RA-22-0089

Duke Energy Carolinas, LLC  
Oconee Nuclear Station (ONS), Units 1, 2, and 3  
Docket Numbers 50-269, 50-270, and 50-287  
Renewed Facility Operating License Nos. DPR-38, DPR-47, and DPR-55

Subject: Response to Request for Additional Information (RAI) Regarding Application to Revise Technical Specification 3.7.7, "Low Pressure Service Water (LPSW) System," to Extend the Completion Time for One Required Inoperable LPSW Pump on a Temporary Basis

**RESPONSE TO REQUEST FOR ADDITIONAL INFORMATION**

Figures 1-7 below are provided for Large Cold-Leg Break LOCA scenarios with the LPSW C pump failure assumed at three different times:

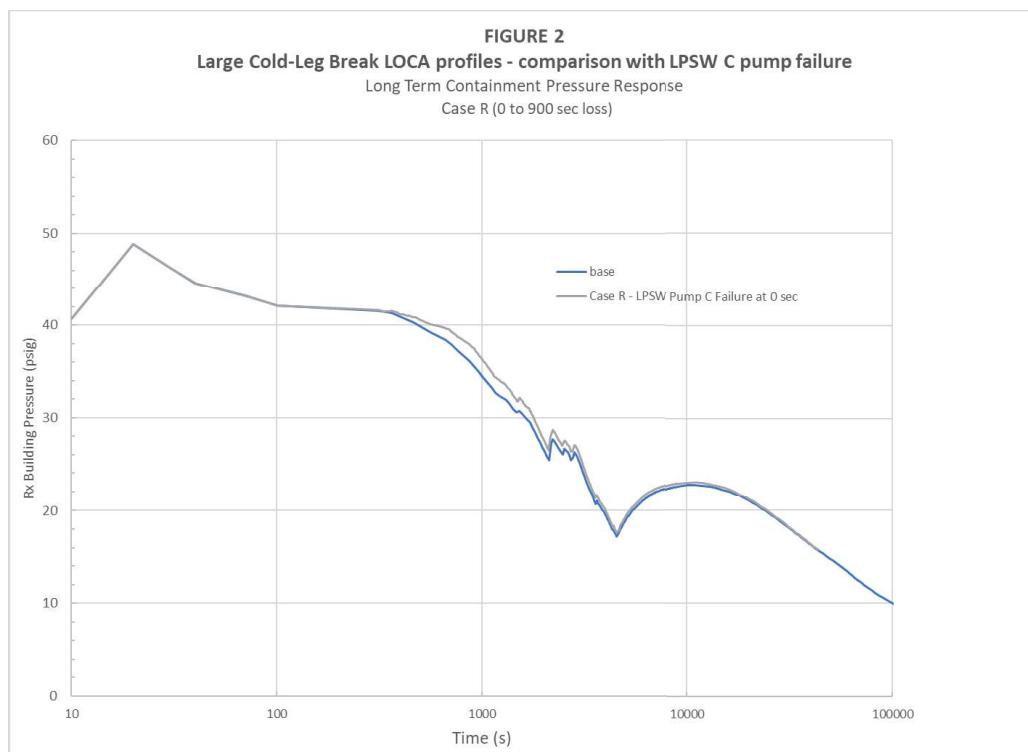
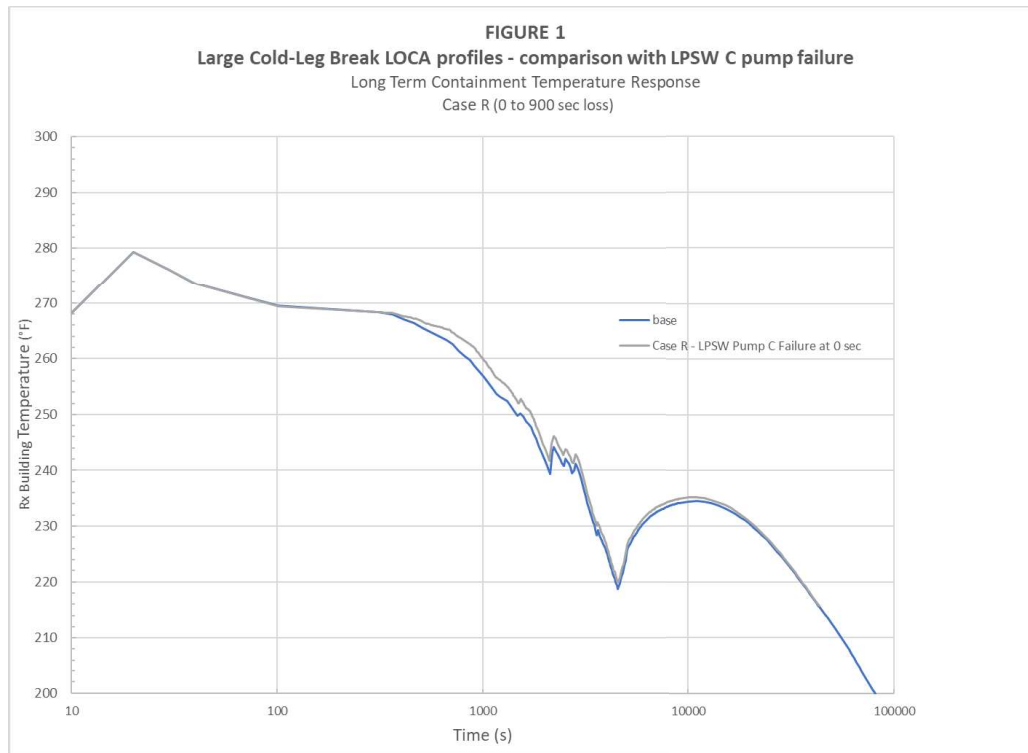
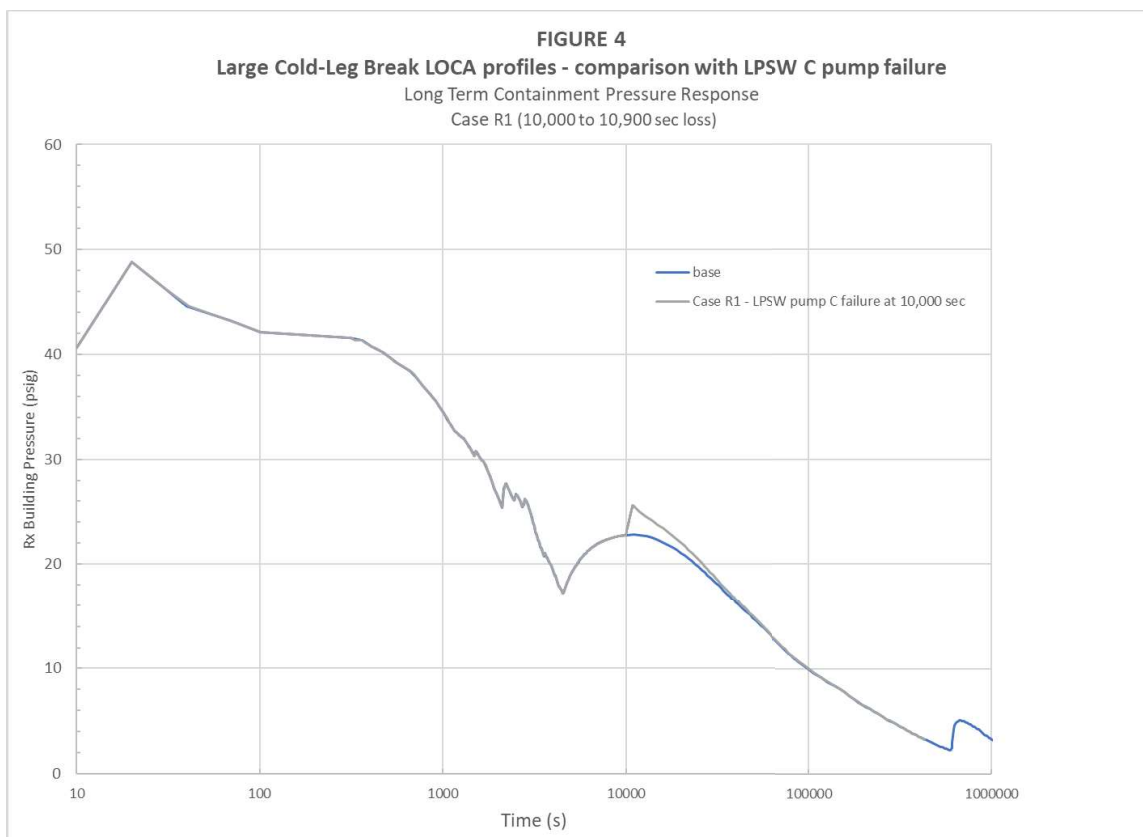
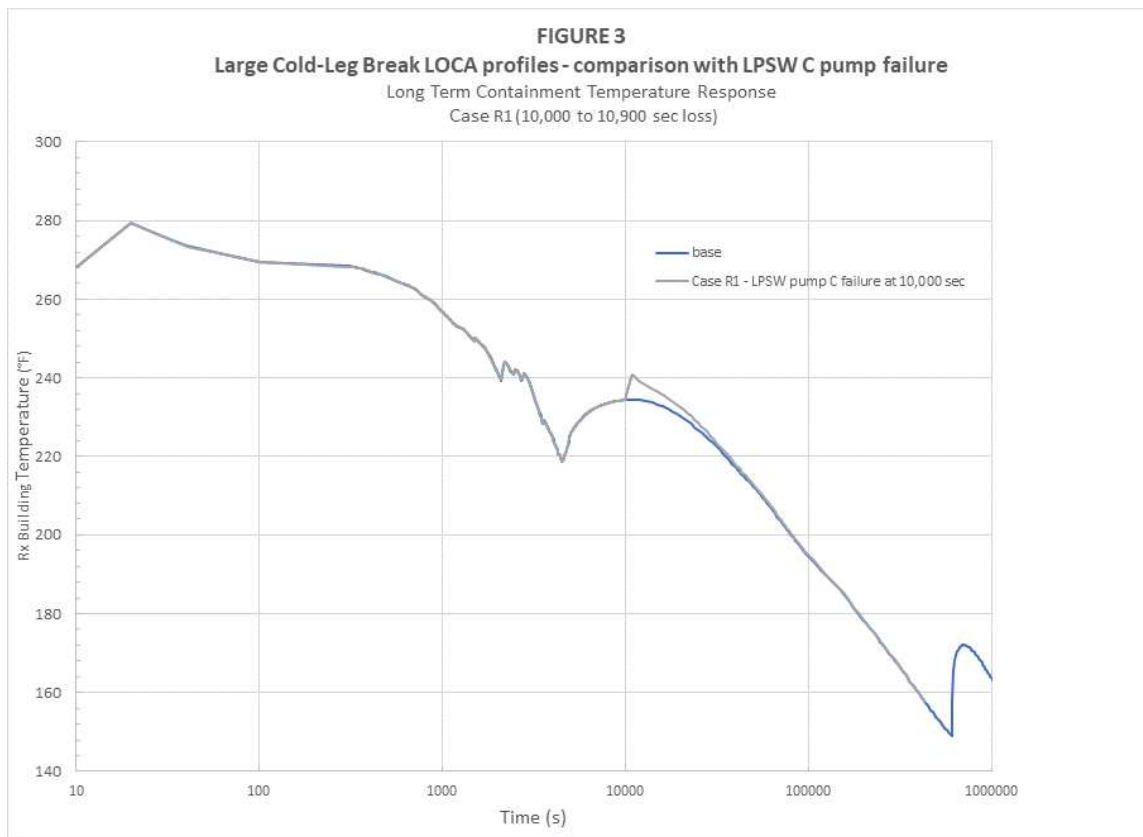
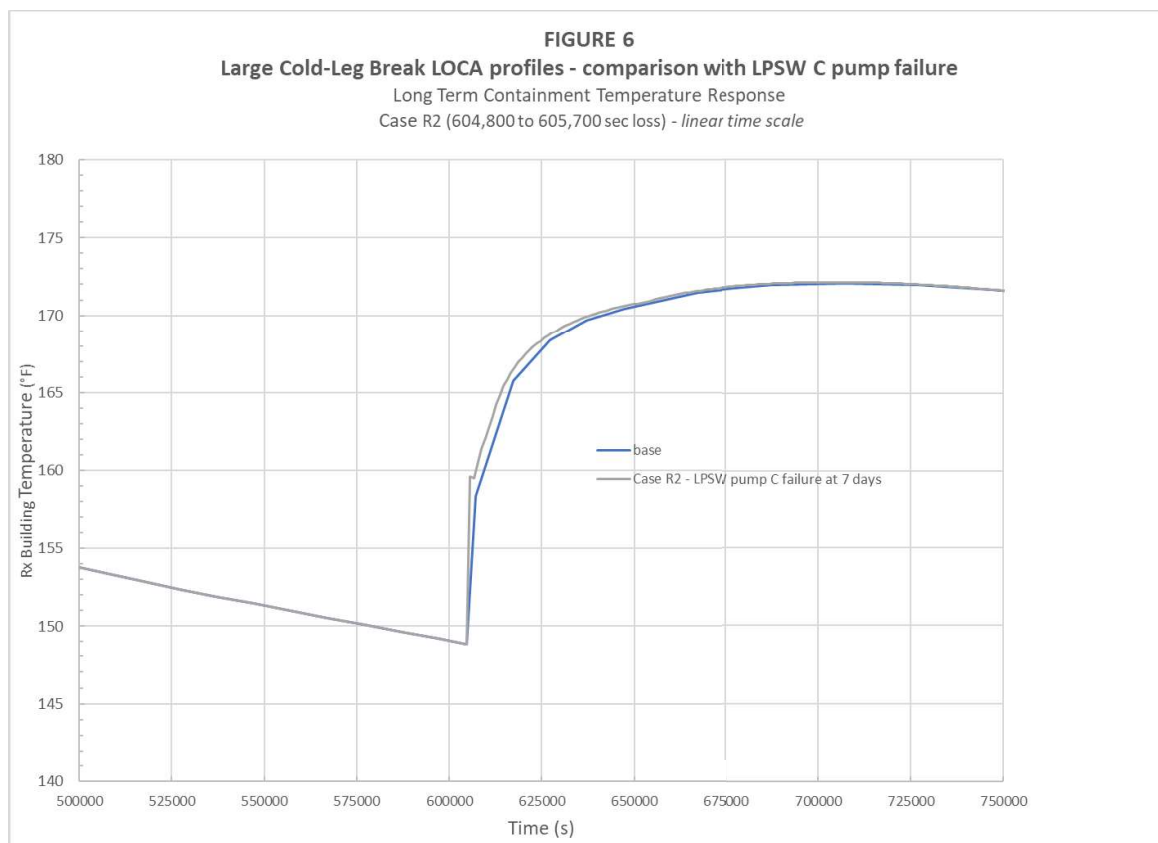
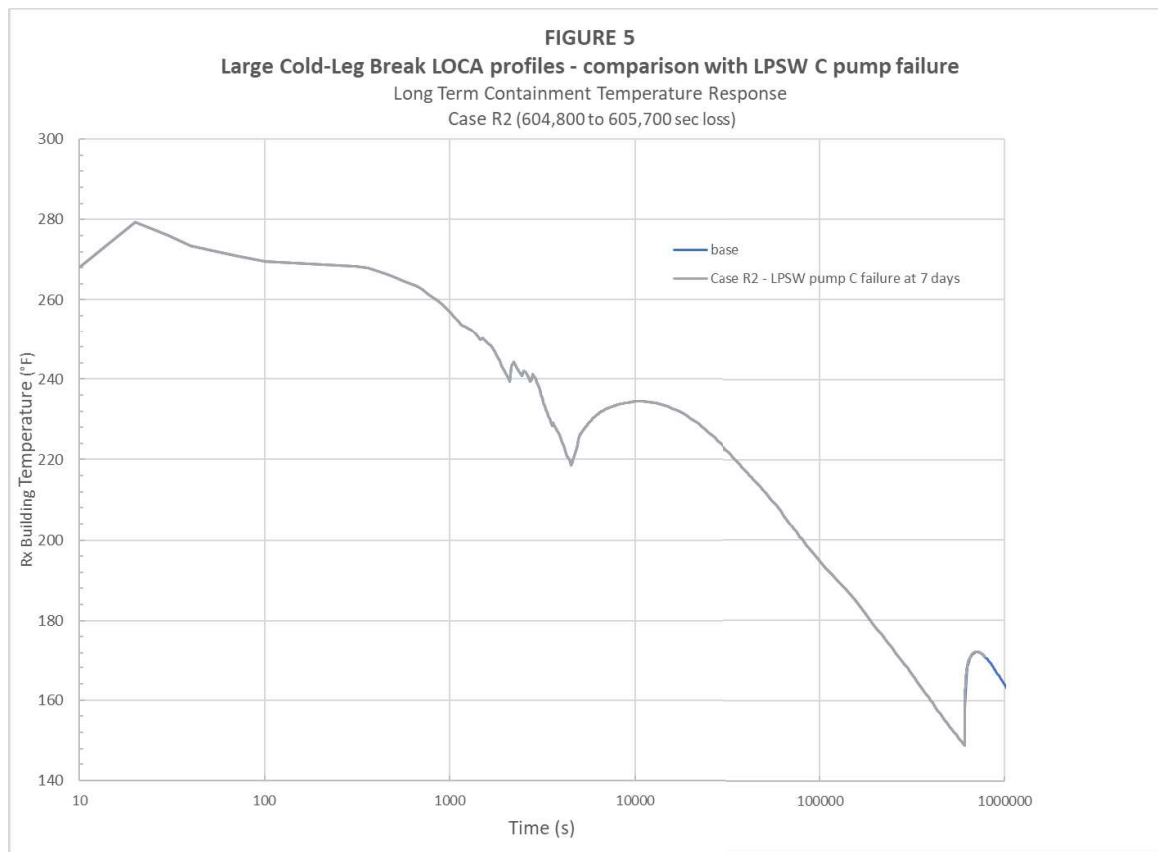
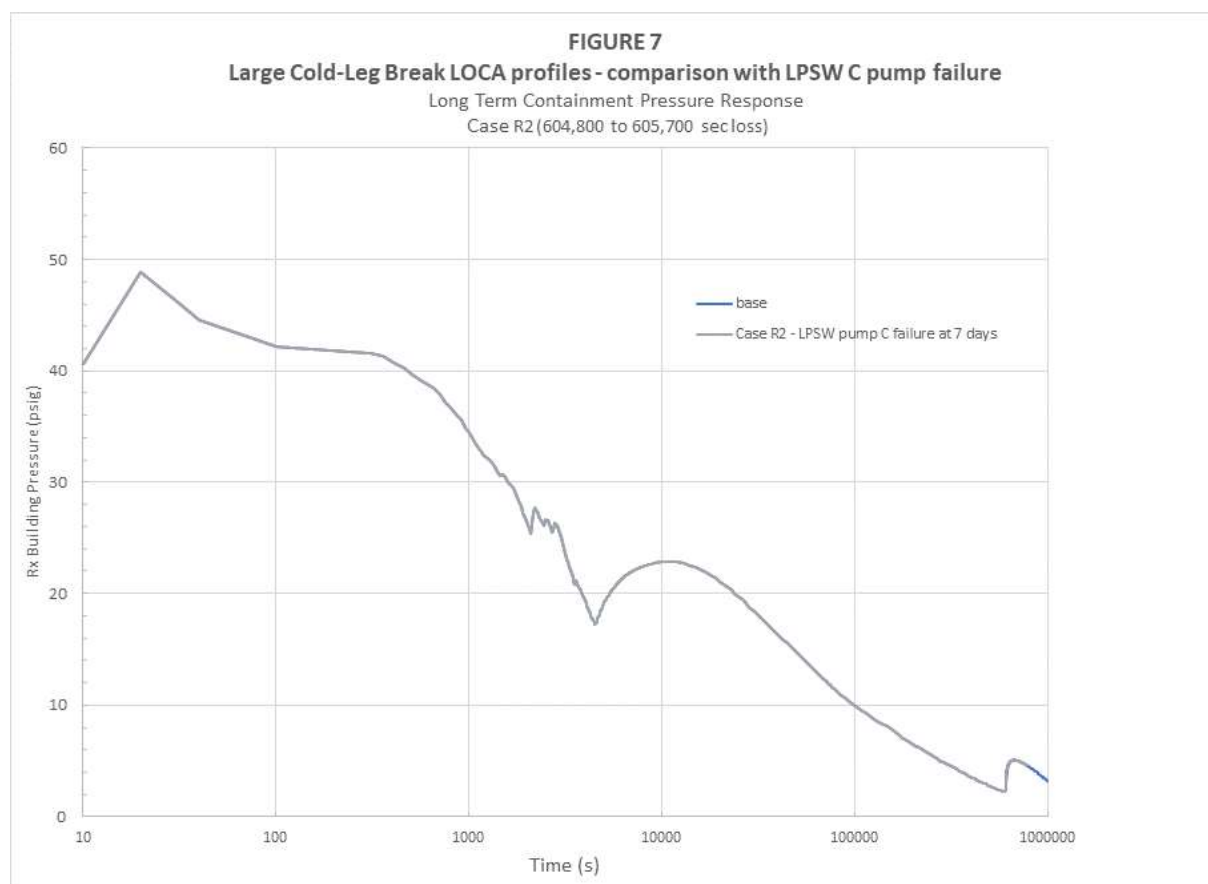
- (b) During the period in response to (a) containment cooling would stop completely. The UFSAR analysis of record (AOR) Figures 6-36 and 6-37 appears to indicate containment pressure and temperature profiles may reverse. With the same analysis inputs and assumptions as in the AOR, provide the containment analysis pressure and temperature profiles, peak pressure, and vapor temperature for the worst-case assuming failure of the LPSW C pump at any time from 0 to 288 hours.

- (c) Confirm that the analysis in (b) shows that the containment peak pressure and peak vapor temperature are bounded by the AOR values in UFSAR Figures 6-36 and 6-37, respectively.

- 1) Case R – LPSW C pump failure at  $t=0$
- 2) Case R1 – LPSW C pump failure at  $t=10,000$  seconds. This is at the approximate time when Reactor Building (RB) pressure / vapor temperature trends have reached their peak values after sump recirculation mode has been entered.
- 3) Case R2 – LPSW C pump failure assumed at  $t=7$  days. For the AOR, it is assumed that RBS pumps are terminated at this point in the transient. The termination of those spray pumps causes a decrease in steam condensation in the RB atmosphere, leading to a short duration where RB vapor temperatures increase.

In all Figures presented, the cases with postulated LPSW C pump failures are overlaid with the AOR results (UFSAR Figures 6-36 and 6-37). For Case R2, time scales are modified in Figure 6 to facilitate comparison. Also, restoration of LPSW flow to the RBCUs / LPI coolers is assumed to occur 15 minutes after the postulated LPSW C pump failure based on the response to RAI 1(a) above.

For all three cases, the peak pressure and vapor temperature values shown in UFSAR Figures 6-36 and 6-37 are not impacted. This is because these peak values occur early in the transient (about 20 seconds after the LOCA occurs), well before RBCUs are assumed to initiate in the AOR. For Case R with the LPSW C pump failure assumed to occur at  $t=0$ , the time delay in restoring LPSW flow to the RBCUs of 15 minutes means that only 10 minutes of RBCU cooling is lost (RBCU initiation is assumed to occur at  $t=5$  minutes in the AOR).

The time when RB peak pressure / vapor temperature values are reached is also well before sump recirculation mode is entered, so any postulated failure affecting LPSW flow to the LPI coolers has no impact at this early stage of the transient.

Based on the response to RAI 1(b), it is confirmed that for all cases executed for the 1(b) response, the containment pressure and peak vapor temperature values are bounded by the AOR values shown in UFSAR Figures 6-36 and 6-37.

**FIGURE 8**  
**OCONEE NUCLEAR STATION**  
**HOT LEG BREAK ANALYSIS FOR NPSH REQUIREMENTS**  
**INITIAL BUILDING CONDITIONS @ 15.9 PSIA AND 152°F WITH 100% RH**  
**LOSS OF REACTOR BUILDING SPRAY PUMP**  
**RBCU = 120E6 BTU/HR, LPSW = 86.5°F, BWST = 105°F**

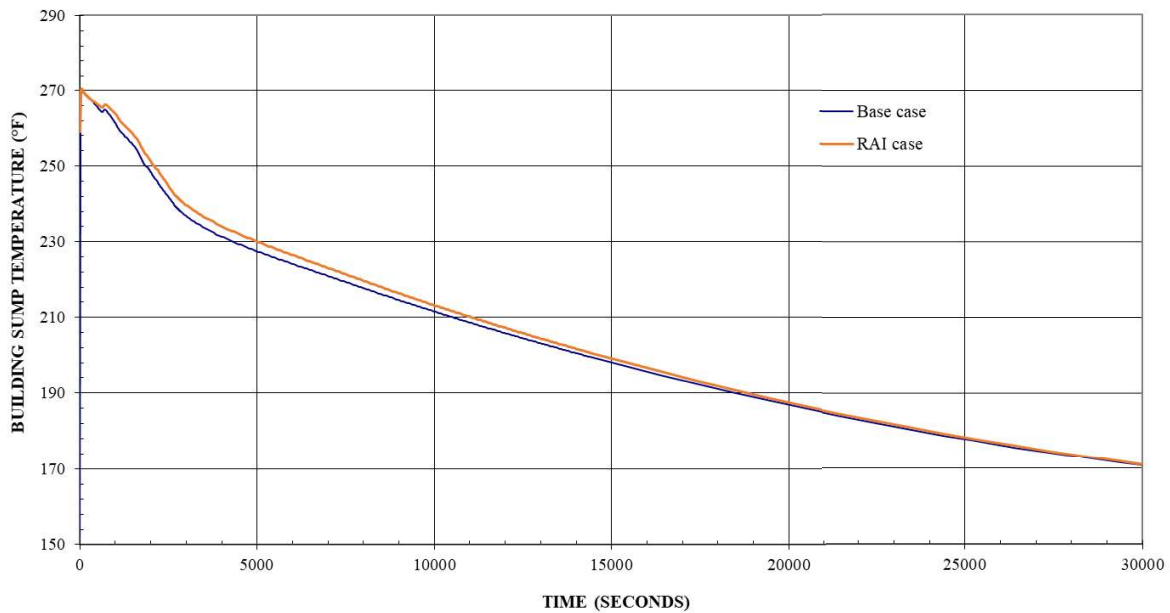
- the peak containment wall temperature based on the peak vapor temperature remains bounded by the AOR containment structural design temperature.
- (f) Due to the absence of LPSW flow to RBCU and LPI coolers for the period in (a) during anytime between 0 to 288 hours, show that the worst-case sump temperature profile remains bounded by the AOR temperature profile. If it is not bounded, please provide the following:

- I. Revised sump temperature profile.
  - II. Available net positive suction head (NPSH) profile(s) for the pumps that draw water from the sump during the LOCA recirculation phase.

The Reactor Building sump temperature results for the large hot-leg break LOCA case are shown in Figure 8. This trend is overlaid from the case without the postulated LPSW C pump failure. The sump temperature difference is small at first, but gets larger until the time of switchover to sump recirculation mode. This difference reaches a maximum value of about 3°F. This difference will start to decrease further into the transient as RBCU/LPI cooling will compensate for the difference. This will allow the sump temperature differences to decrease over time, and for the trends to converge.

At the time when sump recirculation mode is entered (2677 seconds), the sump temperature in the case with the LPSW C pump failure has decreased to 242.3°F. This is about 3°F warmer than the same time in the base case, where the sump temperature is 239.4°F at this time.

**FIGURE 10**  
**OCONEE NUCLEAR STATION**  
**HOT LEG BREAK ANALYSIS FOR NPSH REQUIREMENTS**  
**INITIAL BUILDING CONDITIONS @ 15.9 PSIA AND 152°F WITH 100% RH**  
**LOSS OF REACTOR BUILDING SPRAY PUMP**  
**RBCU = 120E6 BTU/HR, LPSW = 86.5°F, BWST = 105°F**

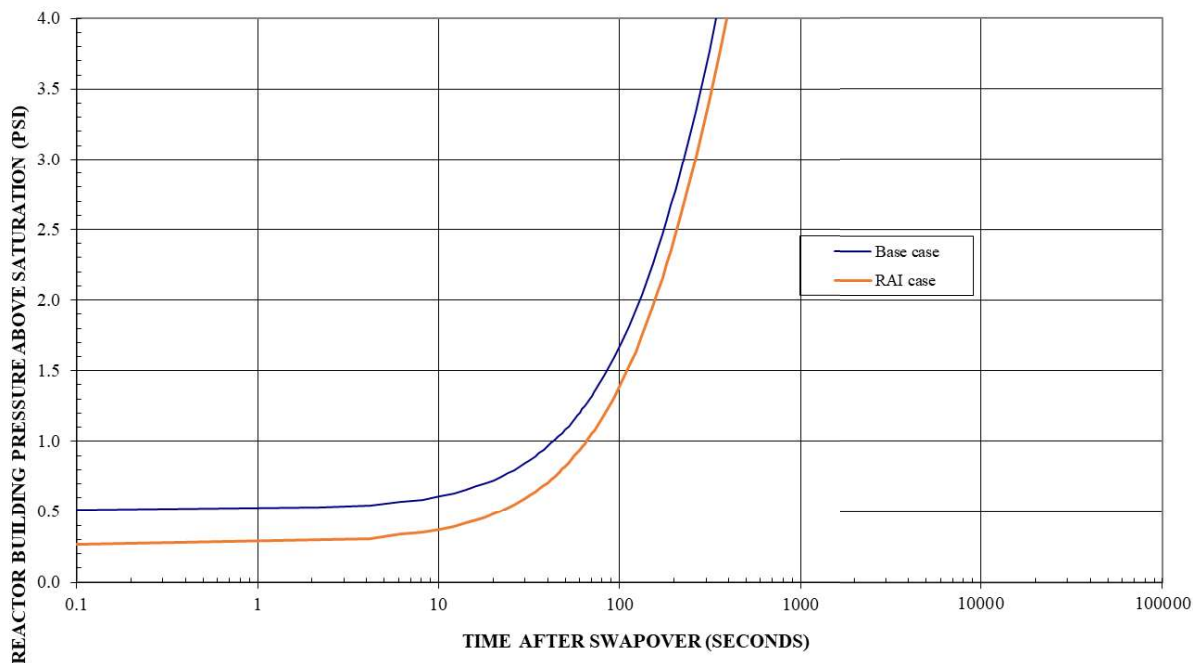
- III. Minimum NPSH margin for the pumps in (ii) and the containment accident pressure (CAP) below the vapor pressure at sump temperature used in calculating this margin.

A profile for the available Reactor Building overpressure (as a function of time after sump recirculation mode is entered) is shown in Figure 10. This trend is overlaid from the case without the postulated LPSW “C” failure. The reduction in overpressure just after switchover to sump recirculation mode is shown in this trend. The amount of available RB overpressure increases to >2 psi within several minutes.
